**UNITED STATES
NUCLEAR REGULATORY COMMISSION**

SUBJECT: SEQUOYAH FUELS CORPORATION - NRC INSPECTION REPORT
040-08027/2017-003

Sequoyah Fuels Corp.
NRC Inspection Report 040-08027/2017-003

Phase 3 Leachate Collection Area, 300m²

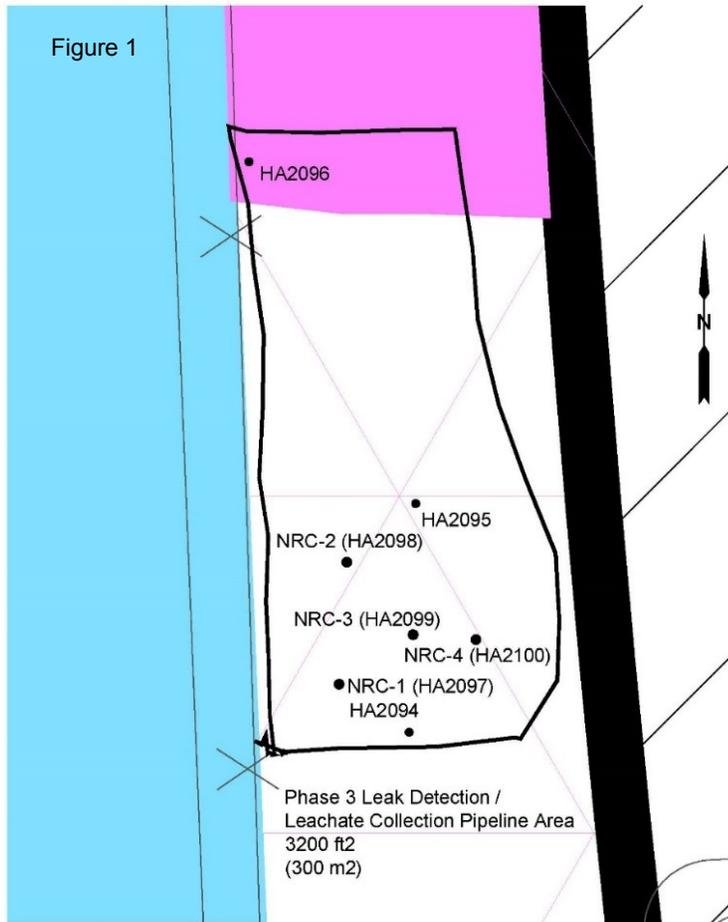
Table 1: Licensee Final Status Survey Results (see Figure 1, below)

In summary, the licensee’s records indicate that the excavated area had been effectively remediated. The scan survey results were less than the action level. In addition, the licensee collected a sufficient number of soil samples. All soil sample results were less than the cleanup level specified in the reclamation plan. Final residual contamination levels met all of the applicable clean-up levels with walkover survey results less than the action level of three times background and total uranium in soil results of 100 pCi/g or less.

Table 2: Split Sample Results (see Figure 1, above)

The inspector compared the sample results to the NRC-approved cleanup level of 100 pCi/g for total uranium. Both sets of sample results were less than the cleanup level. Further, the inspector noted that the NRC's sample results were similar to the licensee's sample results, suggesting reasonable correlation between the two laboratories. Some variations in sample results can be explained by different laboratory sample protocols and possible inadequate mixing of split samples in the field. Both laboratories identified the most elevated sample as being the same.
